# HISTORIC DISTRICT COMMISSION

## CERTIFICATE OF APPROPRIATENESS

**Application Number:** HDC2025-00011

# HISTORIC DISTRICT COMMISSION ADDITIONAL INFORMATION REQUEST

DWG# 03-149-51 SHEET A-1

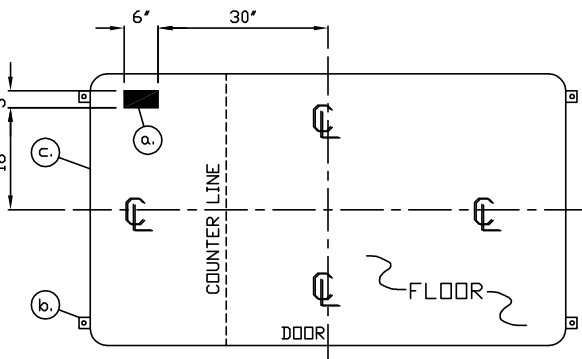
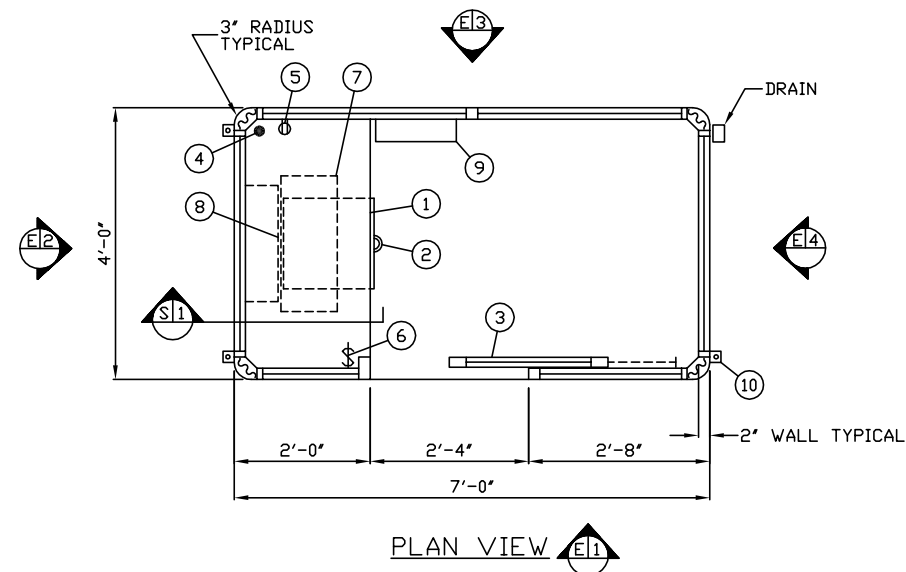
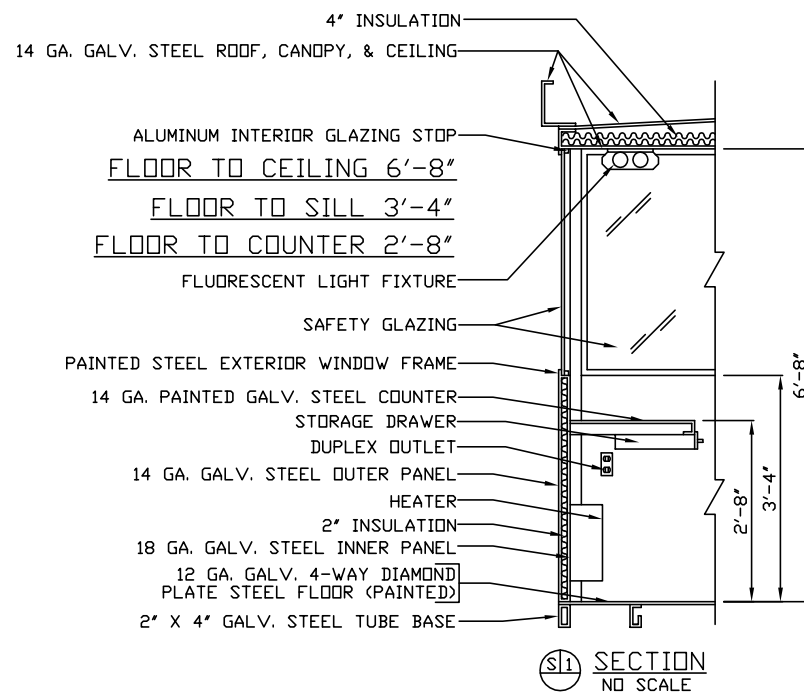
Dear applicant, you have provided an elevation of the trash enclosure but we still need more information on the cashier booth. At a minimum we would need an elevation and would need to know the materials. Thank you.

The booth will be a per-assembled style unit similar &/or equal to Par-Kut model attached. size will be 4' x 6'
